TOWN OF ERIE POLICE DEPARTMENT ADDITION & RENOVATION

TOWN OF ERIE
ERIE PD - ADDITION & RENOVATION
1000 TELLEEN AVENUE, ERIE, COLORADO 80516
COVER SHEET

07/02/25 1st Review

The development review team has reviewed the applications for the Erie Police Station Expansion Drawings for conformance with Town Standards and Specs.

SHEET IDENTIFICATION
C-101

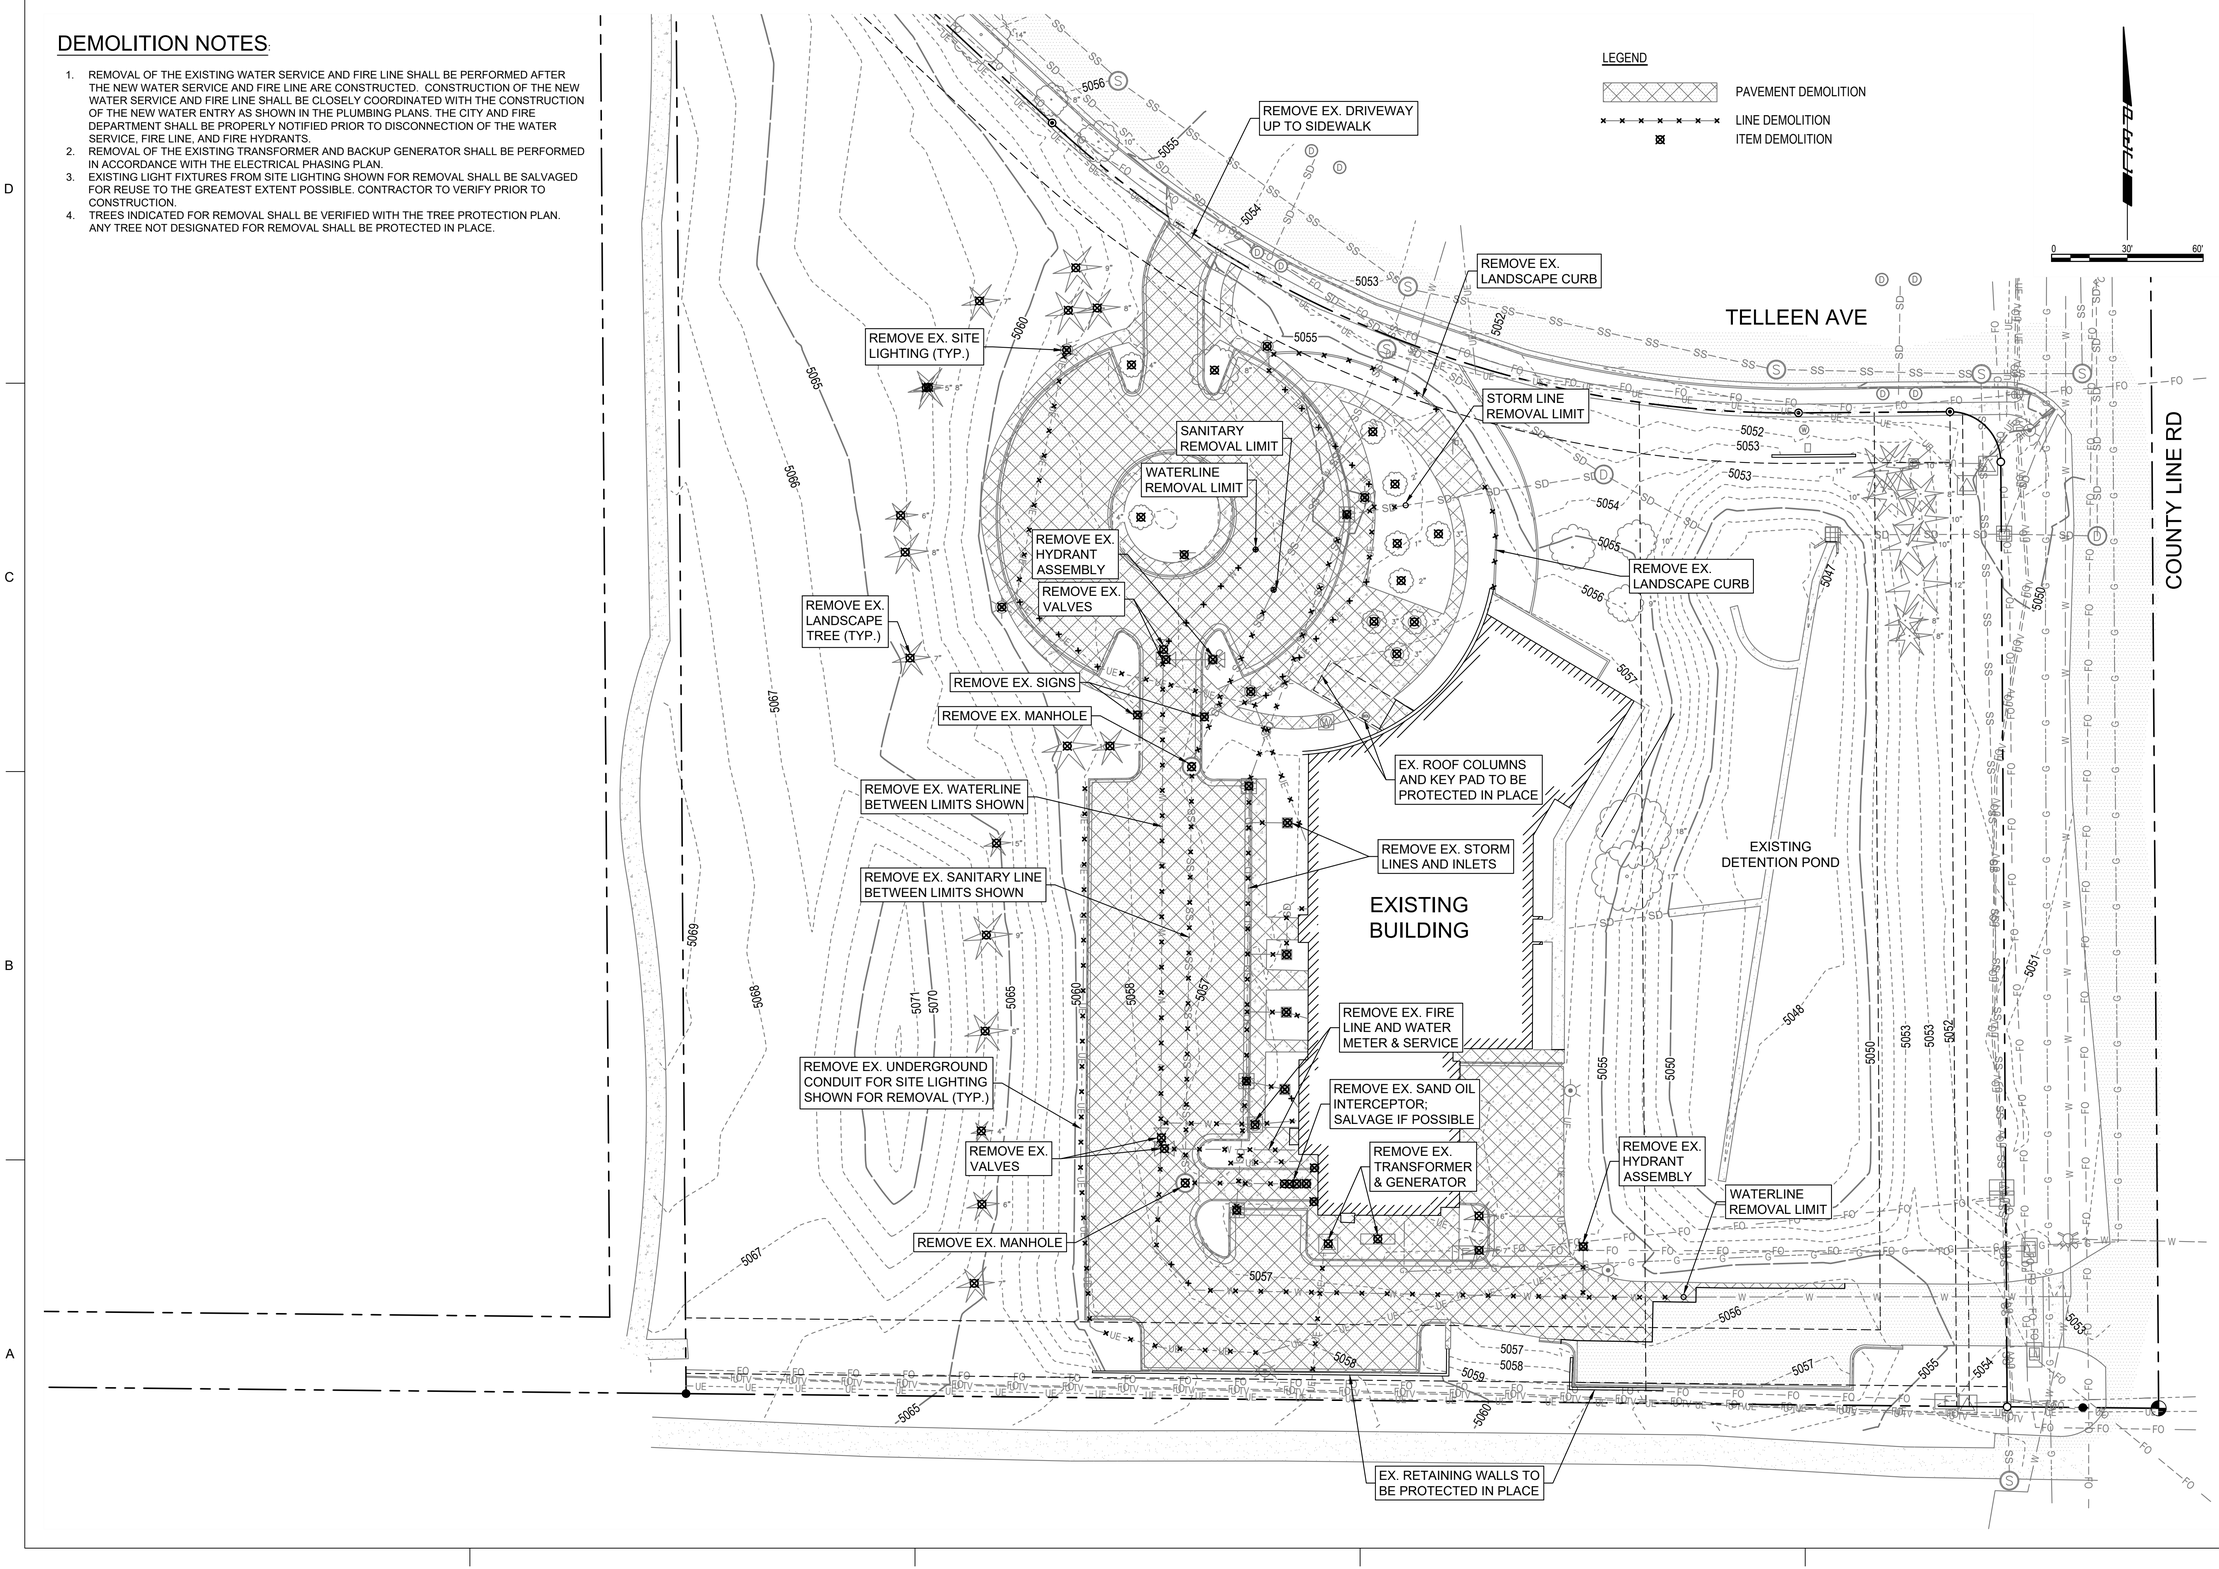
6. The original pond design provided a forebay at the north existing storm sewer outfall. Confirm that this feature still exists and label on Sheet C-101 Existing Conditions. Also, provide a forebay for the new south storm sewer outfall.

a. Existing forebay labeled on Sheet C-101 Existing Conditions. Existing forebay is an earthen forebay with heavy vegetation to collect sediment and provide energy dissipation. Proposed storm sewer outfall into southern end of existing detention pond is a concrete forebay with baffle wall for energy dissipation and riprap boundary for overtopping flows.

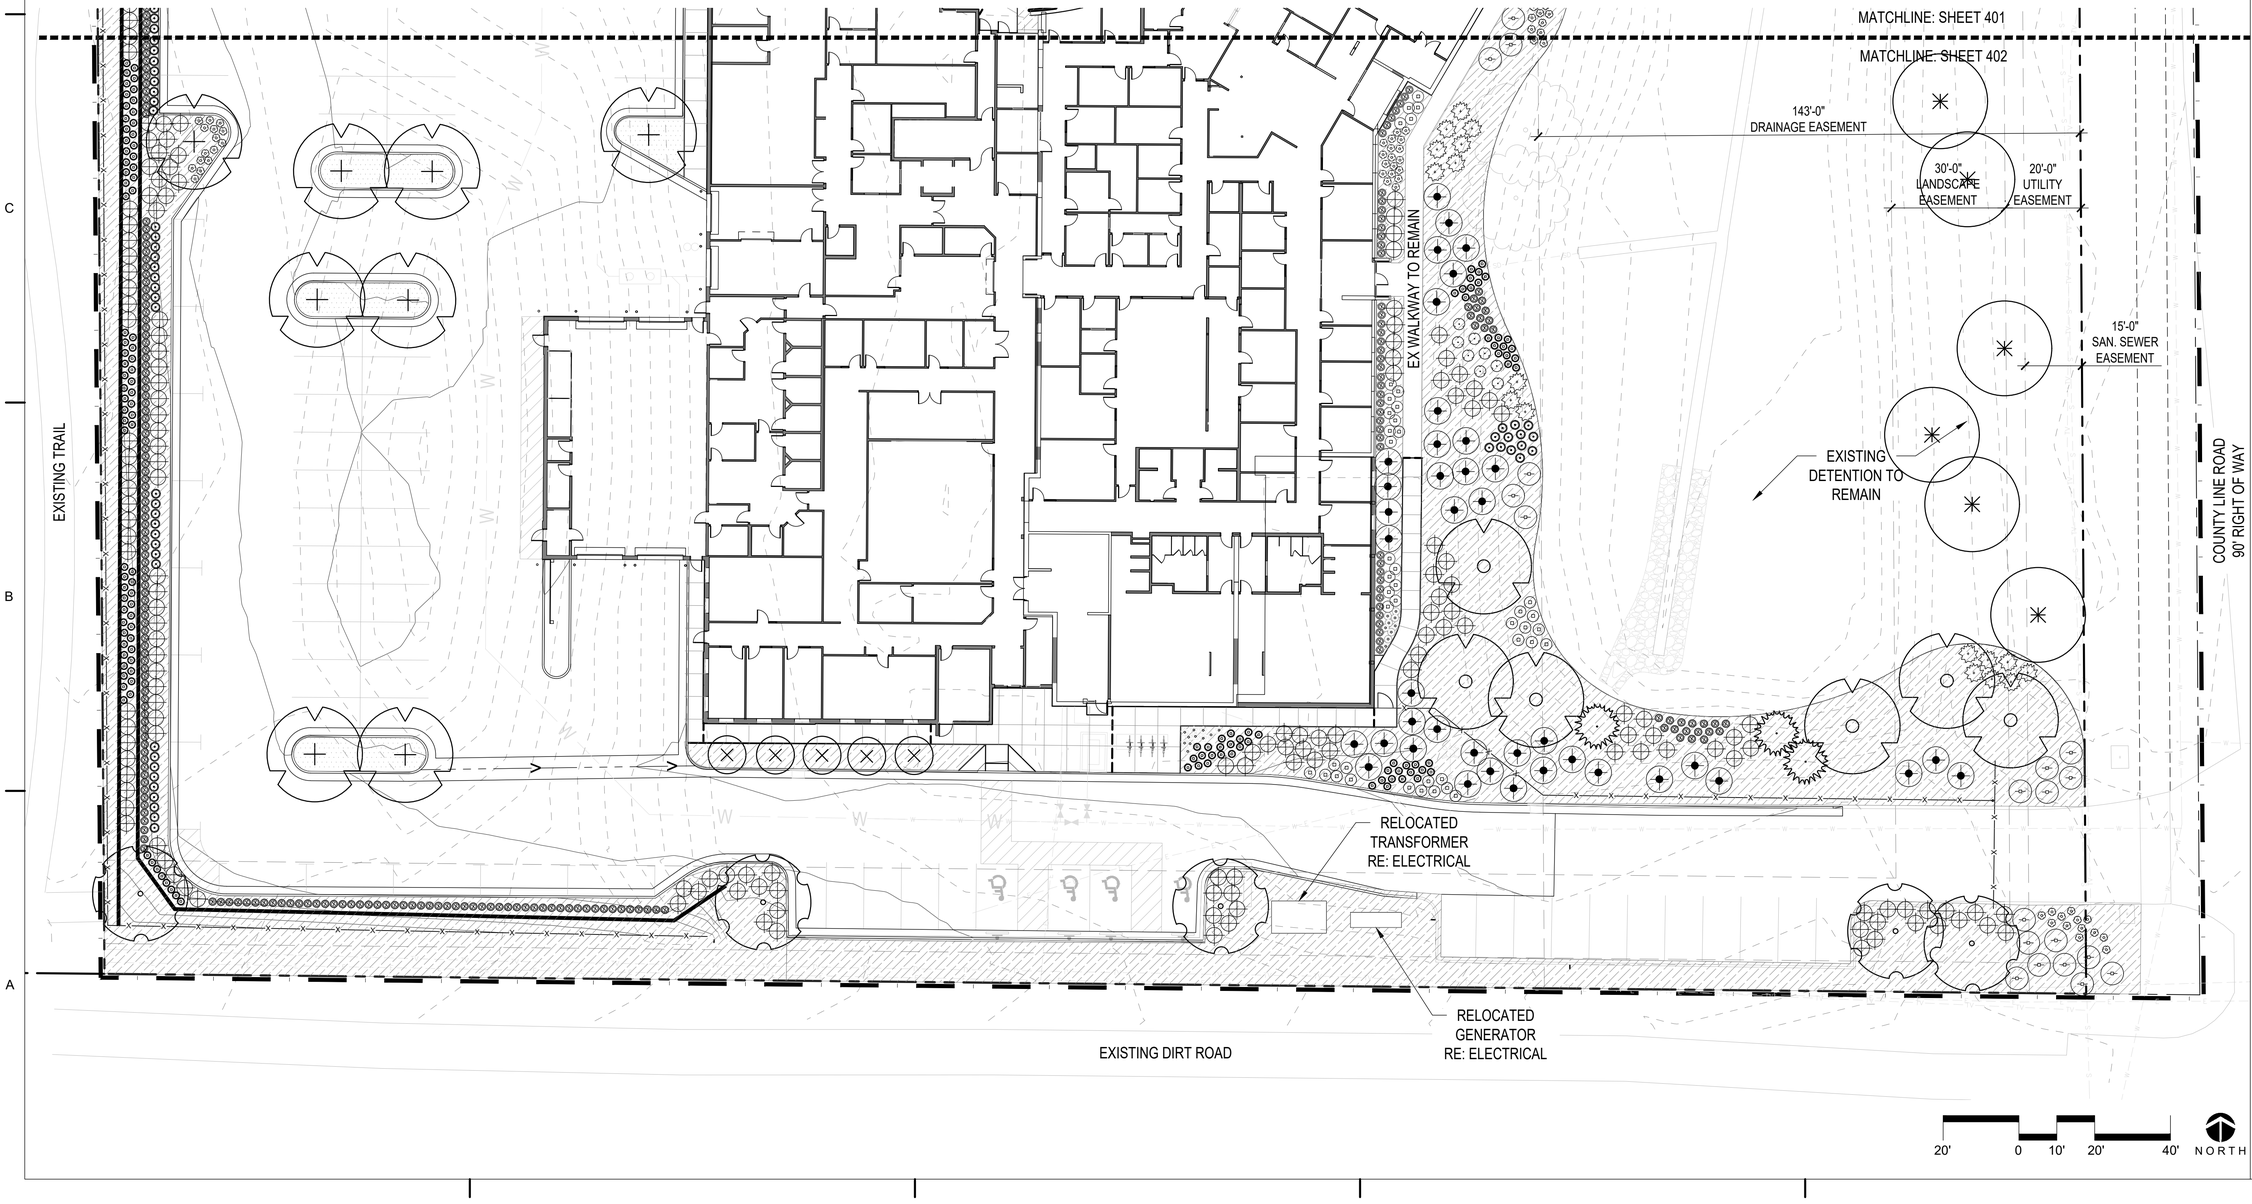
These proposed trees above what's required may offset the tree removal and can count towards tree replacement requirements listed on Sheet 31

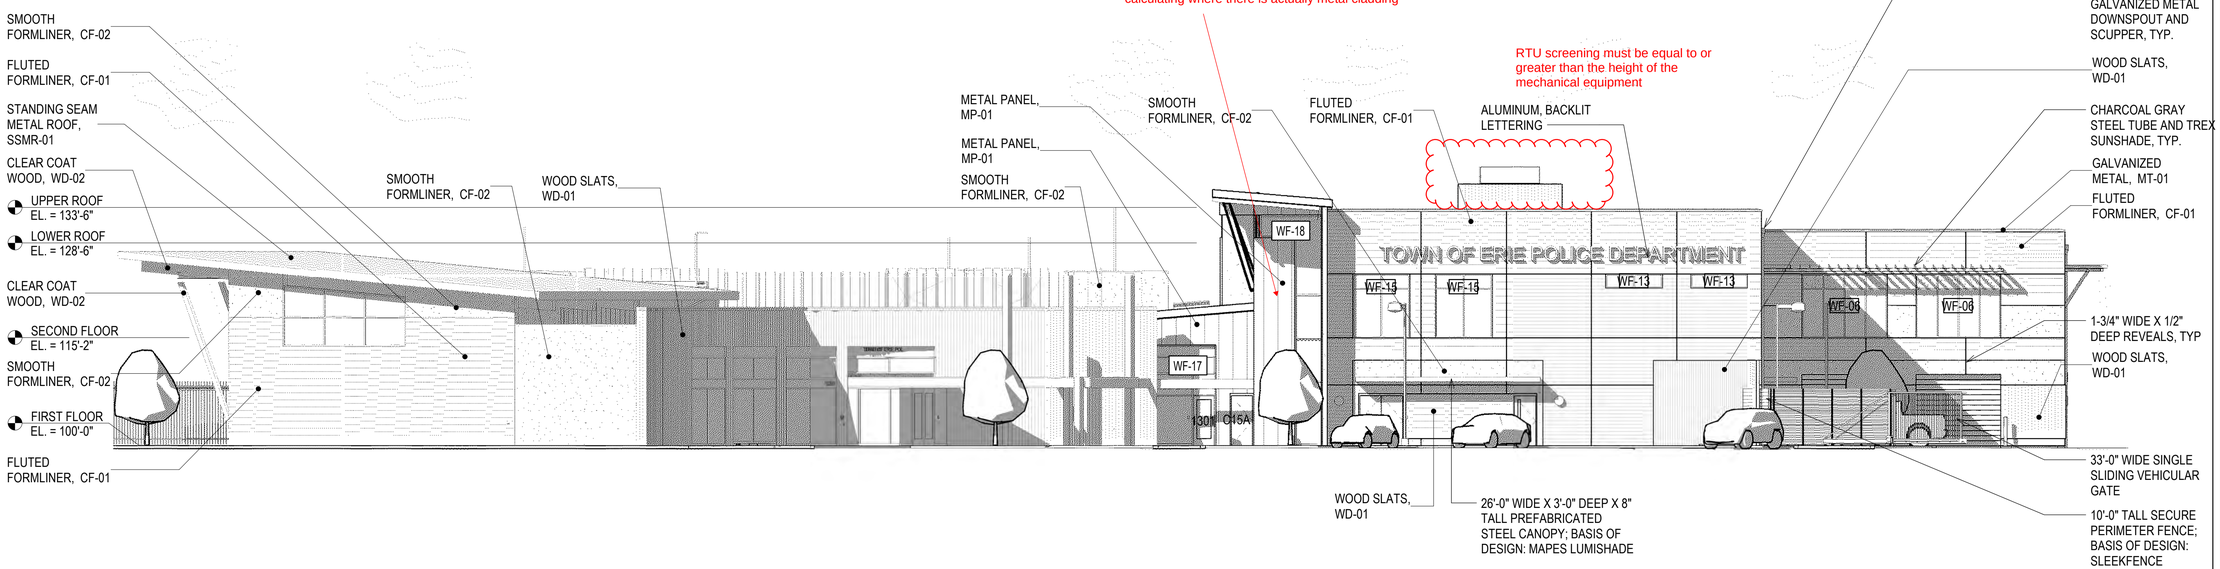
No more than 25 percent of each façade of the building shall be finished with metal material. Metal materials used shall be compatible with the historic character of the DT and NMU Old Town district. **Note - it looks like these elevations are under 25%, we wouldn't count canopies, trim, RTU screening, garage doors etc., it's just calculating where there is actually metal cladding

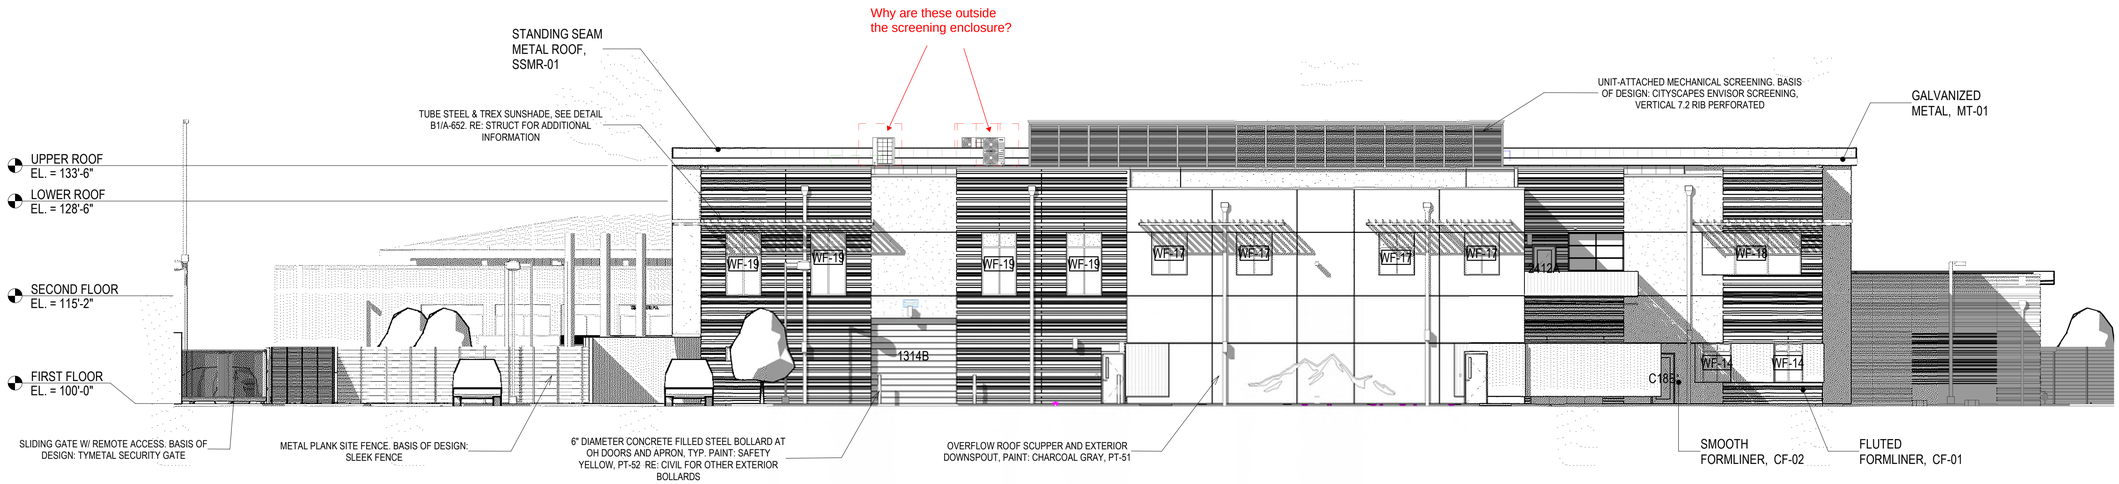
Why are these outside the screening enclosure?

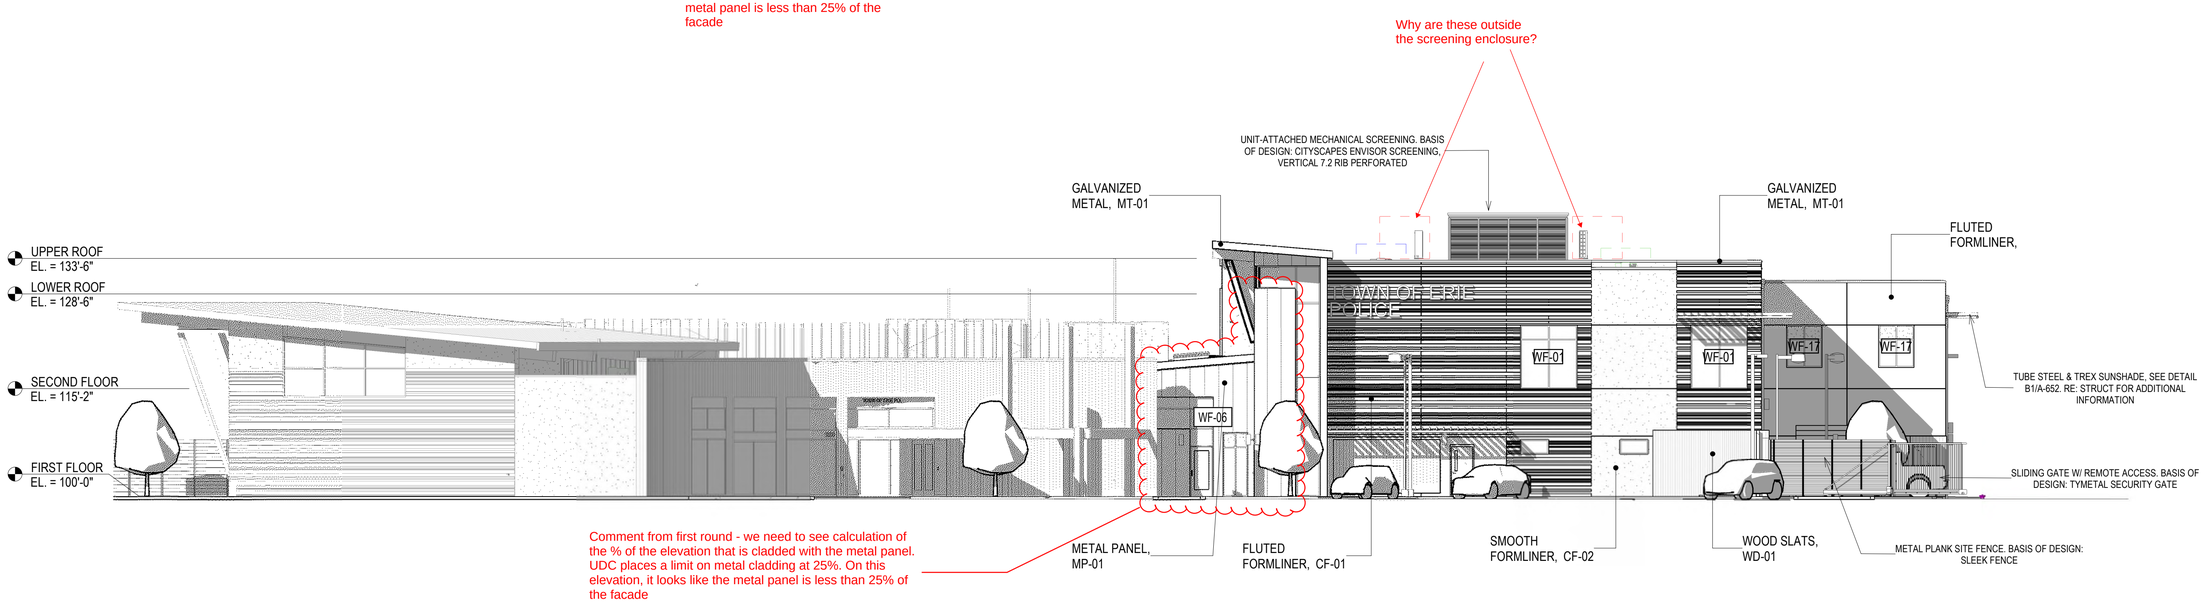
Comment from first round - we need to see calculation of the % of the elevation that is cladded with the metal panel. UDC places a limit on metal cladding at 25%. On this elevation, it looks like the metal panel is less than 25% of the facade
